**VILLAGE OF DOWNERS GROVE  
REPORT FOR THE VILLAGE COUNCIL MEETING  
FEBRUARY 21, 2012 AGENDA**

<b>SUBJECT:</b>	<b>TYPE:</b>	<b>SUBMITTED BY:</b>
Annexation with Rezoning to B-2, Lot Consolidation and Special Use for a drive-through use	<ul style="list-style-type: none"> <li>✓ Resolution</li> <li>✓ Ordinance</li> <li>Motion</li> <li>Discussion Only</li> </ul>	Tom Dabareiner, AICP Community Development Director

At the February 7, 2012 Village Council meeting, the Council discussed annexation, rezoning, lot consolidation and a special use for a Walgreens store at the northwest corner of 63rd Street and Woodward Avenue. The Council asked several questions, requested additional information and suggested changes to the plans.

### **Changes to Site Plan**

Revised Landscaping Plan

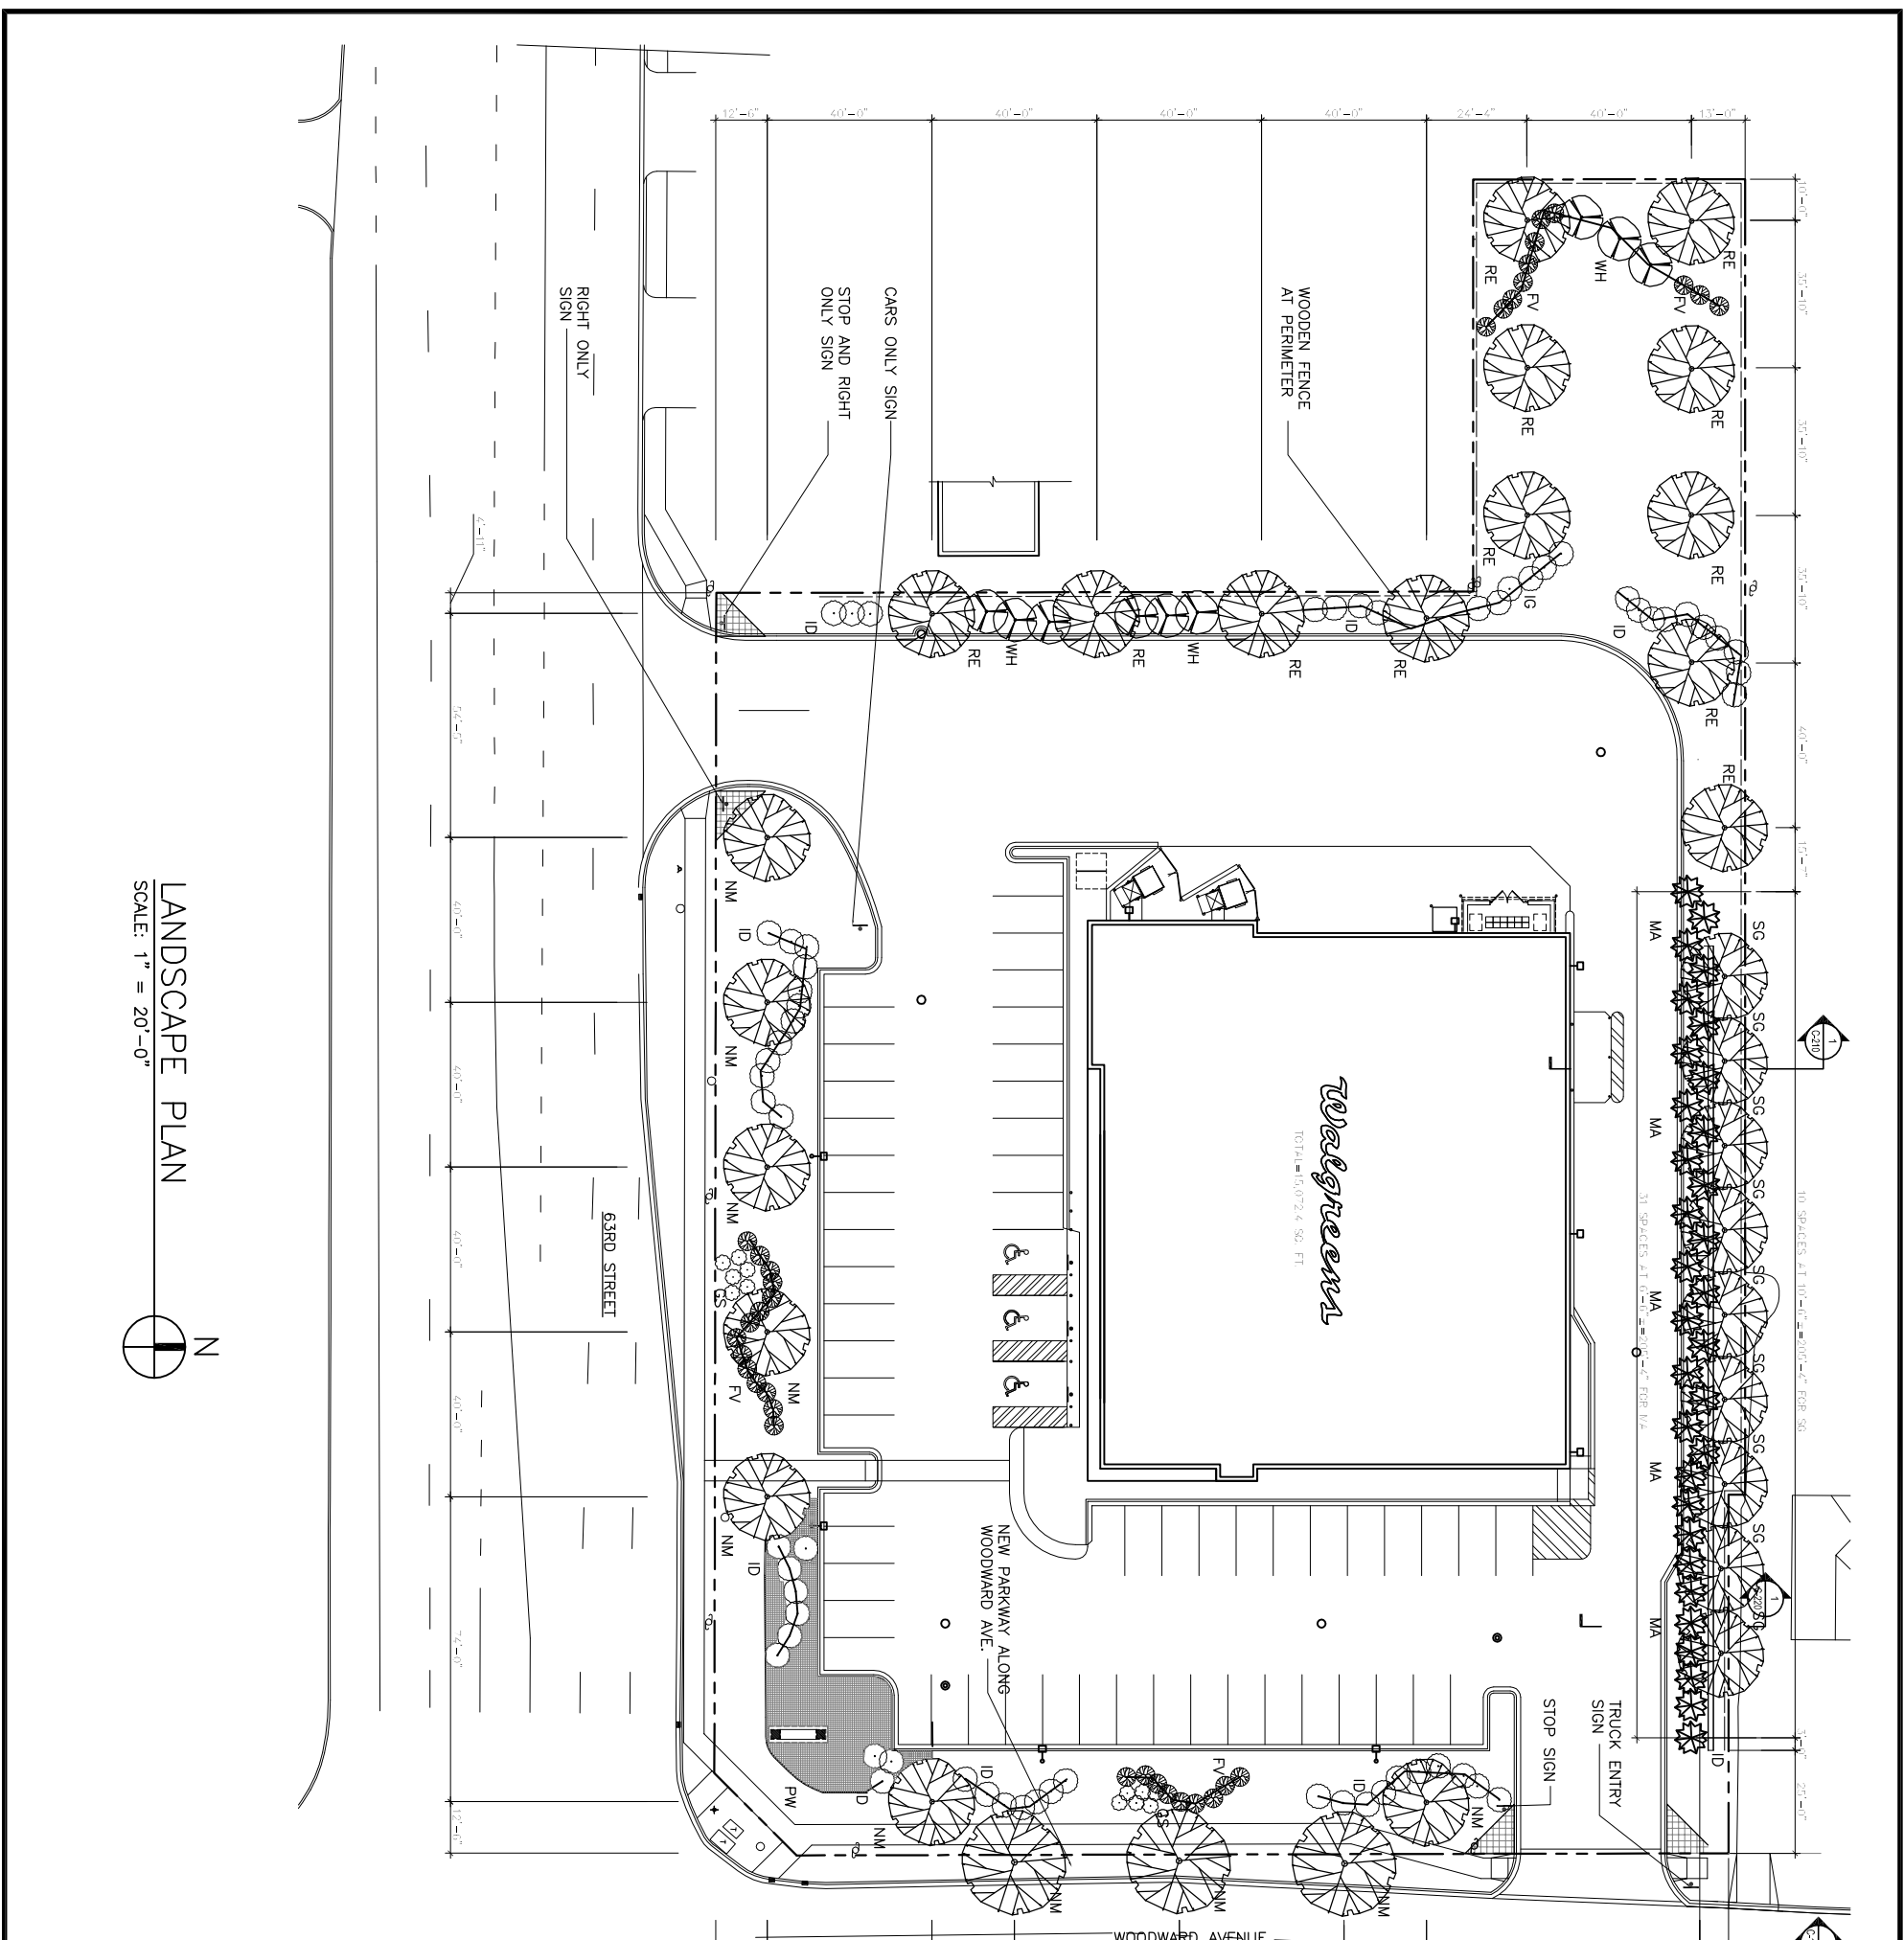
Increase the landscaping along the north lot line – The reduction of five feet in the north drive aisle allows for five additional feet of landscaping. The landscape plan includes nine additional deciduous trees between the two rows of arborvitae and the six-foot wood fence. The revised landscaping plan is attached.
